TCA VENTURE® SAFETY RECALL PRIOR 10.28.11

Product Under Safety Recall Notice

ALL Thompson Center Venture Rifles manufactured prior to October 28, 2011.

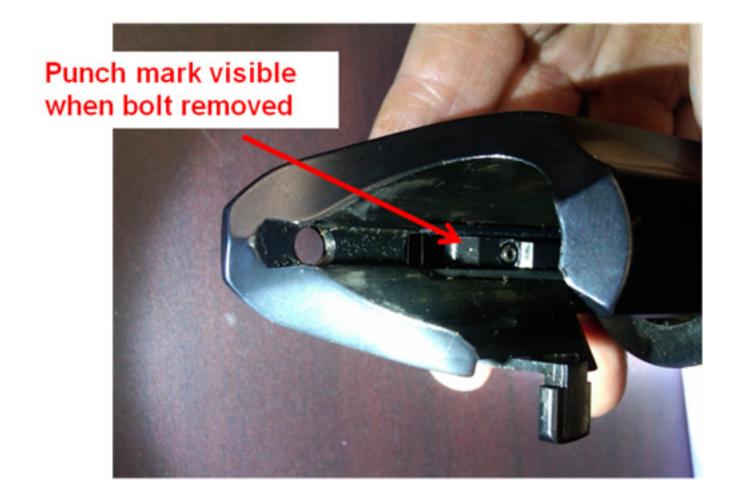
During an internal technical review, Smith & Wesson identified a condition that may exist with the sear supplied with some rifles that would allow the rifle to fire without the trigger being pulled. In the interest of consumer safety, we are initiating this recall to allow for the prompt inspection and, if necessary, the repair of each rifle.

Any unintended discharge of a firearm has the potential to cause injury or death, and we ask that you stop using your rifle until we have an opportunity to inspect the sear to make certain that there is no condition which will allow the rifle to fire without the trigger being pulled.

When your rifle sear is returned, you should note a punch dot on the trigger assembly. See the photograph below. This punch dot is confirmation that your sear has been inspected and the hazard has not been found or has been corrected.

When you rifle sear is returned, you should also note a red checkmark on the label on the outside of your box. See the photograph above. This checkmark is further confirmation that you sear has been inspected and the hazard has not been found or has been corrected.
